**City of Richmond**  
Urban Development Division

## Report to Development Permit Panel

**To:** Development Permit Panel  
**From:** Joe Erceg  
Manager, Development Applications  
**Date:** January 24, 2003  
**File:** DP 02-221723  
**Re:** **Application by Husky Oil Marketing for a Development Permit at  
9060 Bridgeport Road**

**2 PROPOSED FENCE**

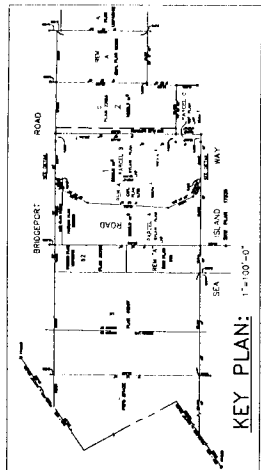
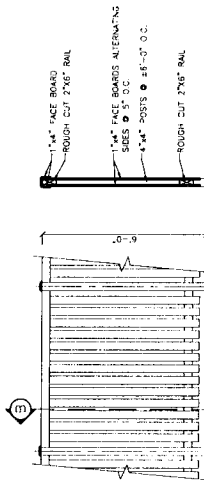
3. It is requested that a 1.5 m (6 ft.) high residential quality wood fence be installed along the east property line respecting the road setbacks on both Bridgeport Road and Sea Island Way. ***The applicant has complied.***

**PROPOSED SITE PLAN**

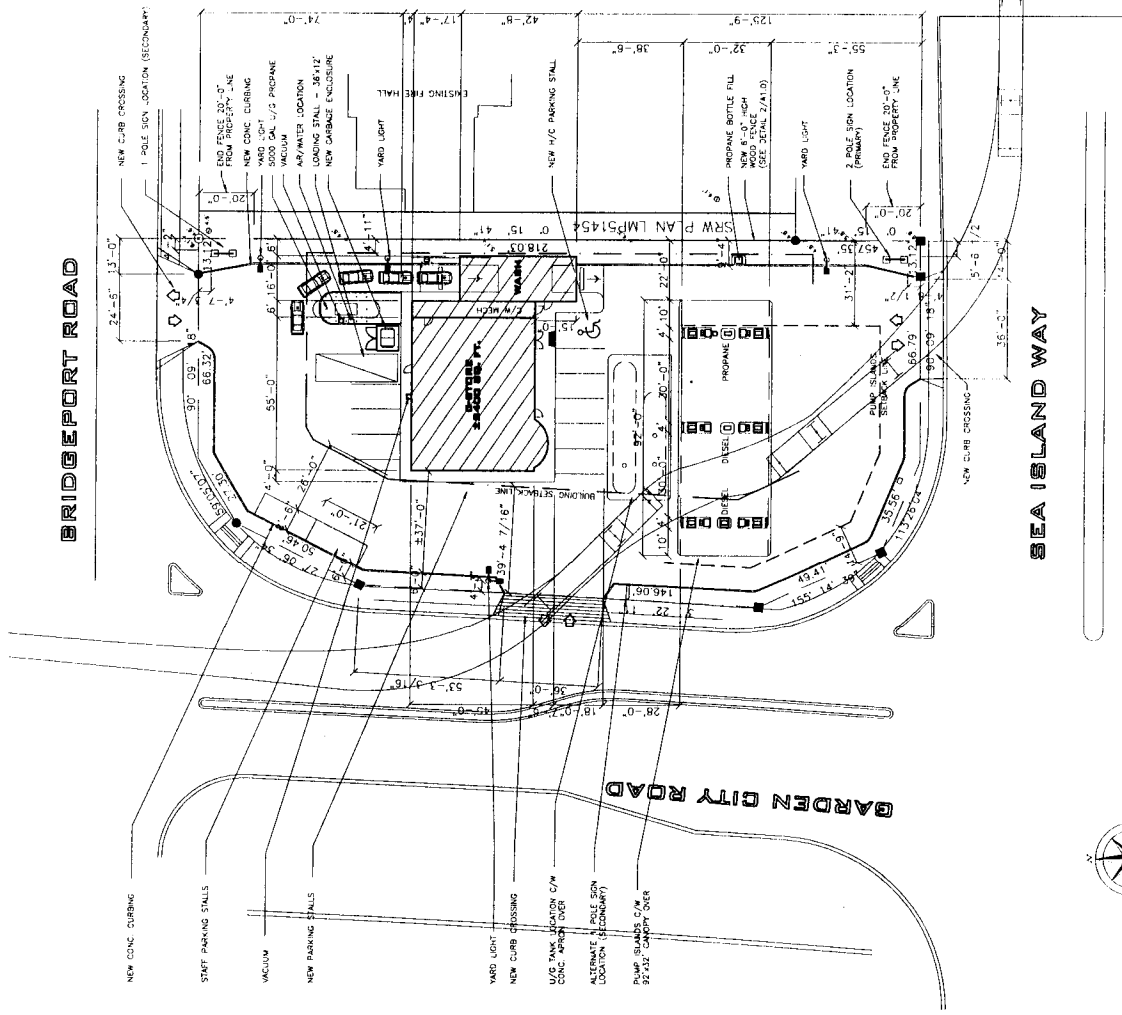
1. It would be preferable if the location for the propane bottle fill station, the air and water station, the vacuum station, the yard lights and the staff parking were not immediately adjacent to the fronting roads, especially if there is not sufficient room for the proposed low, landscaped berm along this frontage. ***The propane bottle filling station, the air and water station and the vacuum station have been relocated away from Sea Island Way. Three Husky/Mohawk signs, three light poles and two parking spaces remain within the 12 m road setbacks around the perimeter of the site.***

2. Please specify the dimensions of any requested variances to the various setbacks on the drawings in metric. Are variances being requested for the propane bottle filling station, the air and water station, the vacuum station and the three Husky/Mohawk signs? If not, please revise the location of these proposed site improvements. ***The propane bottle filling station, air and water station and the vacuum station have been relocated away from Sea Island Way. Dimensions from the property lines have been provided for the three proposed signs.***

1. It would appear that the proposed site plan and the landscape plan do not accurately reflect the off-site improvements the City will be undertaking on Garden City Road, Sea Island Way and Bridgeport Road. Specifically, the proposed location of the new curb, sidewalk and landscaped boulevard is much closer to the proposed new property line than shown on your plans. It is recommended that you contact Scott Groves of our Engineering Department (Tel: 604-276-4179; Fax: 604-276-4197) to obtain the latest functional design of these off-site improvements. This may affect your proposal for a landscape berm along Garden City Road, Sea Island Way and Bridgeport Road. ***The drawings have been revised and reflect the currently proposed roadway reconfigurations around the perimeter of the site. The City of Richmond will construct curb and gutter, sidewalks and driveway crossings on the municipal boulevards along the road frontages of this property while the applicant will install the landscape screening and buffering on-site and the municipal boulevard landscape.***

1. Please provide the rationale for the extra width proposed for the driveway accesses. The City's standard width for the driveway access on Garden City Road would be 11 m (not 13.716 m as proposed) and 7.5 m on Bridgeport Road (not 10.669 m as proposed). In this regard, Richmond Transportation Department staff believe the turning radius for the tanker truck off Sea Island Way is exaggerated or out of proportion. ***The applicant has now proposed a 10.973 m (36 ft.) wide driveway crossing on both Garden City Road and Sea Island Way plus a 7.468 m (24.5 ft.) wide crossing on Bridgeport Road. These crossing widths conform to the City of Richmond driveway crossing standards. However, the applicant has been asked to confirm that the tanker truck turning movements can be performed without unnecessarily impeding traffic on Sea Island Way or Garden City Road. It is inappropriate to assume that the tanker truck may block 3 lanes of traffic in order to enter and/or exit the subject site.***

1. Please specify the height of any proposed berms around the perimeter of the site on the drawings. ***The perimeter berm on all fronting road will be 0.458 m (1.5 ft.) high.***
